CONSTRUCTION QUALITY ASSURANCE

ON-SITE DISPOSAL FACILITY

PHASE II CELL 2

APPENDIX S:
REQUEST FOR CLARIFICATION
OF INFORMATION (RCI)
OSDF Phase II Cell 2 (20102)

Figure 2. PHASE II DATA

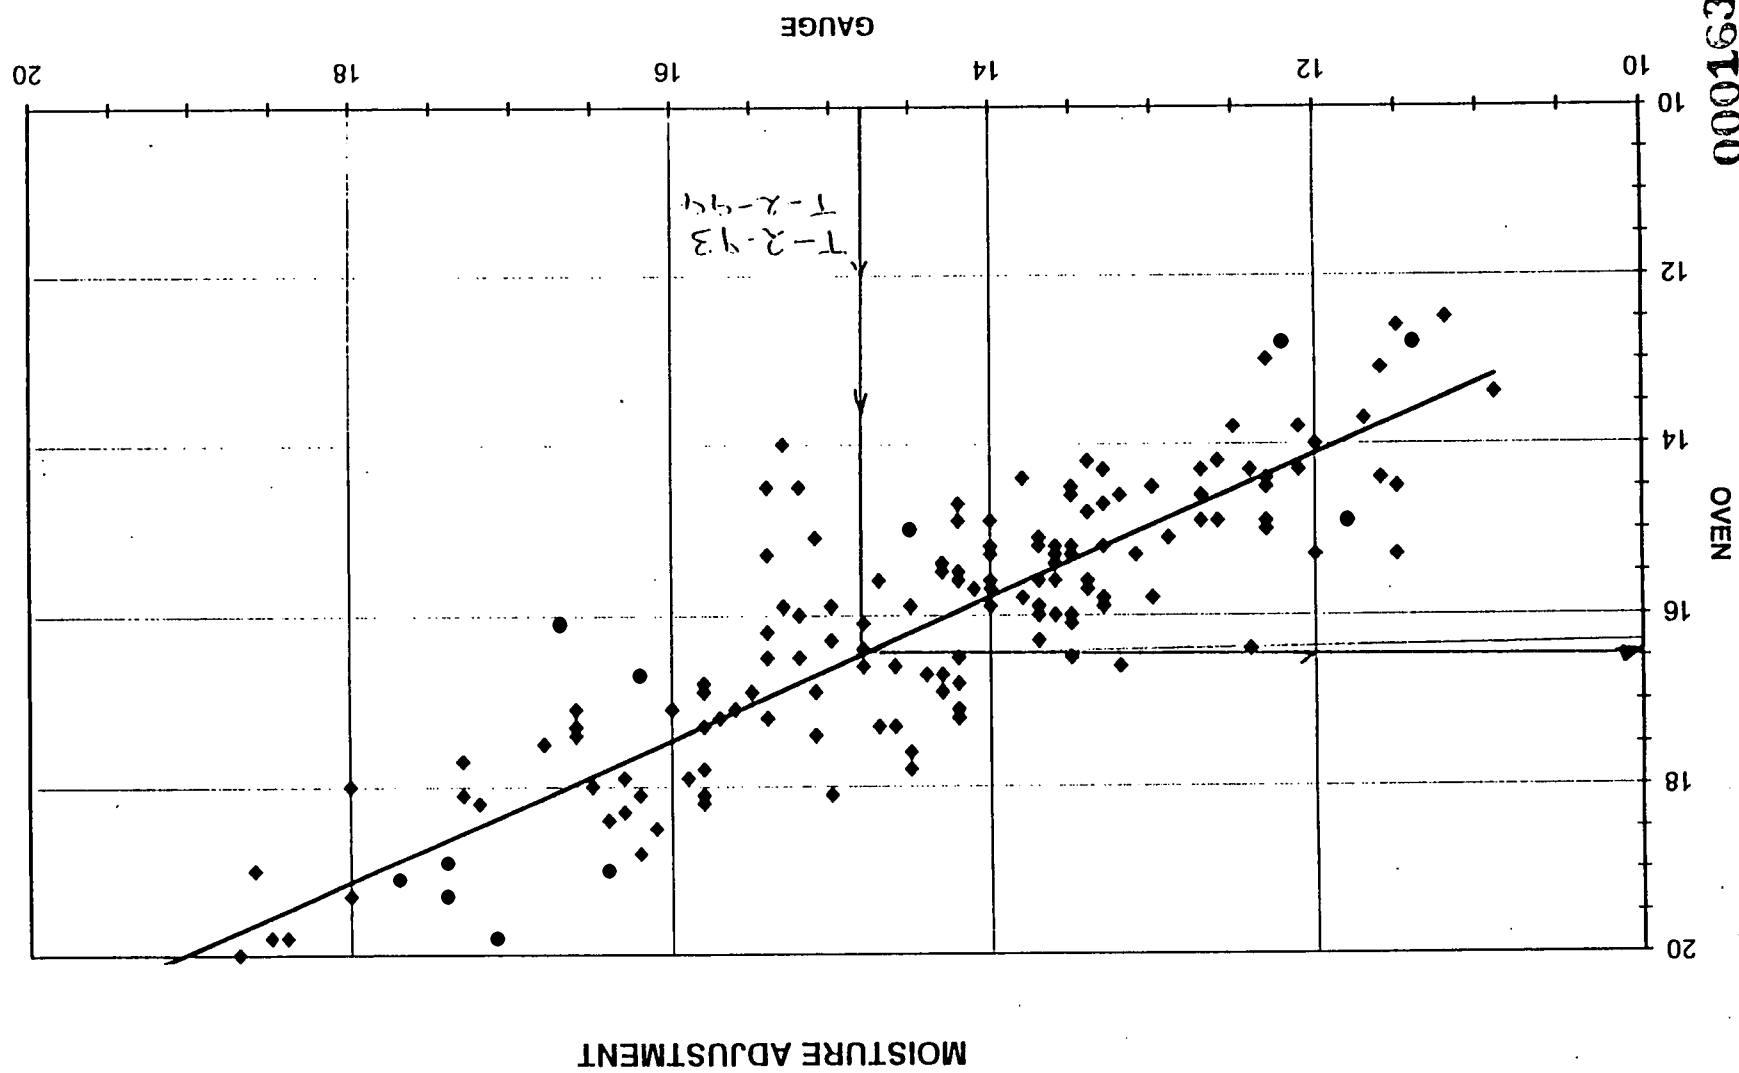
The up-to-date moisture correction data for Phase II construction is presented in Figure 2. Using the best-fit linear regression equation or line from Figure 2 gives an oven moisture content of 15.5% for Test Nos. 2-93 and 2-94. The representative stockpile standard Proctor OMC used for the APZ is 13.3% (average of two tests for stockpile 98-3). Thus the correct FMC value of 15.5 would result in 2.2% above the OMC, and thereby meet the APZ requirement. Therefore, both tests that were initially considered failed tests did indeed passed if the Phase II moisture correction data is used.

Figure 2. PHASE II DATA

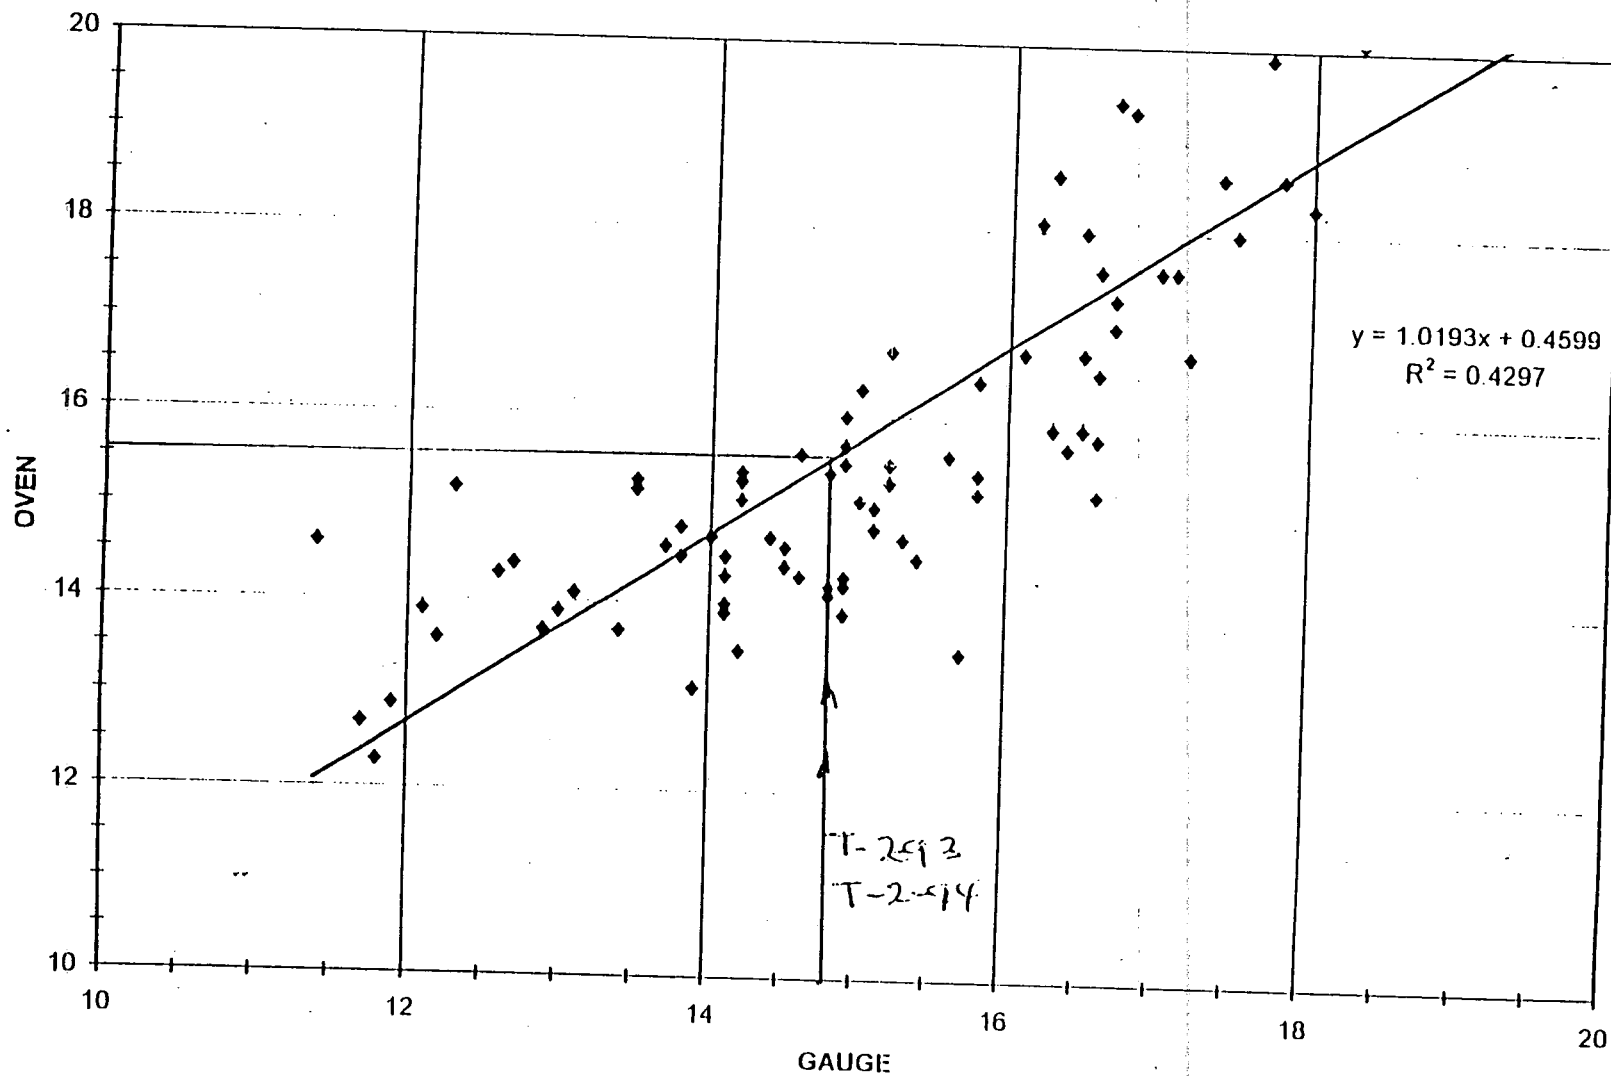
The up-to-date moisture correction data for Phase II construction is presented in Figure 2. Using the best-fit linear regression equation or line from Figure 2 gives an oven moisture content of 15.5% for Test Nos. 2-93 and 2-94. The representative stockpile standard Proctor OMC used for the APZ is 13.3% (average of two tests for stockpile 98-3). Thus the correct FMC value of 15.5 would result in 2.2% above the OMC, and thereby meet the APZ requirement. Therefore, both tests that were initially considered failed tests did indeed passed if the Phase II moisture correction data is used.

Figure 2. PHASE II DATA

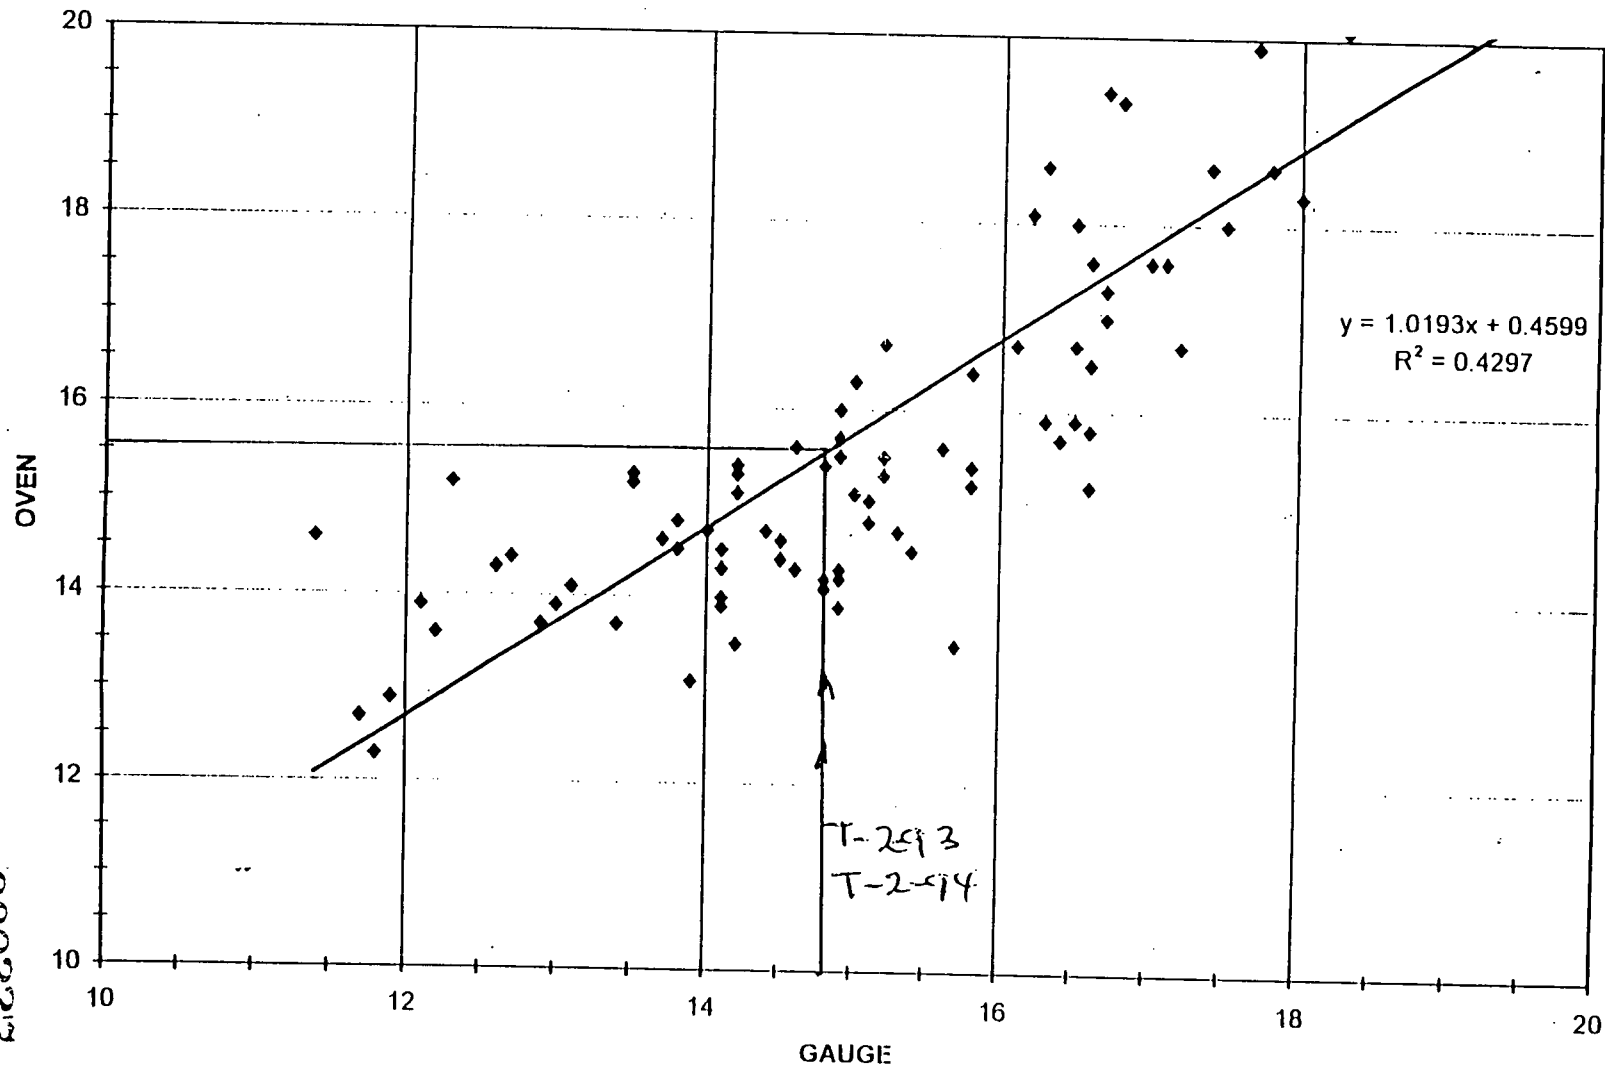
The up-to-date moisture correction data for Phase II construction is presented in Figure 2. Using the best-fit linear regression equation or line from Figure 2 gives an oven moisture content of 15.5% for Test Nos. 2-93 and 2-94. The representative stockpile standard Proctor OMC used for the APZ is 13.3% (average of two tests for stockpile 98-3). Thus the correct FMC value of 15.5 would result in 2.2% above the OMC, and thereby meet the APZ requirement. Therefore, both tests that were initially considered failed tests did indeed passed if the Phase II moisture correction data is used.
